Access Compliance Report Public Rights-of-Way (RR Crossings)

Intersection ID: 13985	Main Street: CAMDEN_RD	Location: N/A
ADA ID: B5FF17909E81	Overall Compliance: No	Severity Score: 0.0
Codes/Mitigation Info/Possible Solution		Field Measurements/Component Compliance

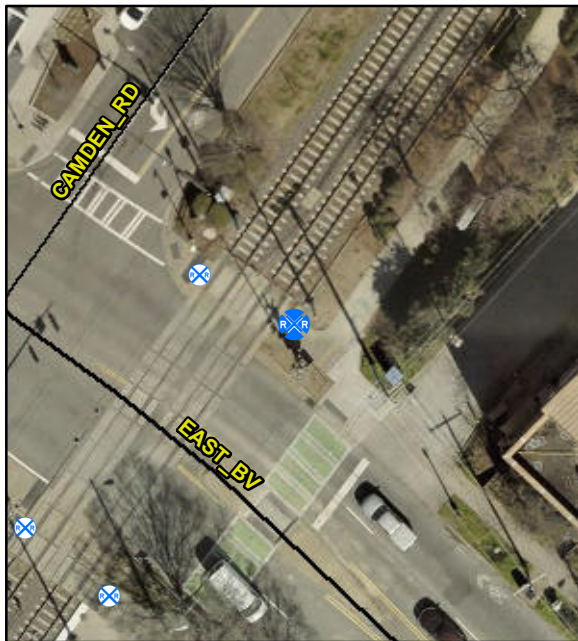
**Remove & Replace Detectable
Warning System. Provide Pedestrian
Gate. Remove & Replace Walking
Surface Adjacent to Rail.**

R302.7.4, R305.2.5

Compliance	Description	Data
Yes	DWS Provided?	Yes
Yes	DWS Contrast?	Yes
Yes	DWS Width (in)	Yes
Yes	DWS Length (in)	36.0
No	DWS Offset (in)	13.0
No	Pedestrian Gate?	No
N/A	DWS Outside Gate?	N/A
N/A	Rail Type?	LightRail
No	Flangeway Gap (in)	3.0
Yes	Sidewalk Width (in)	78.0
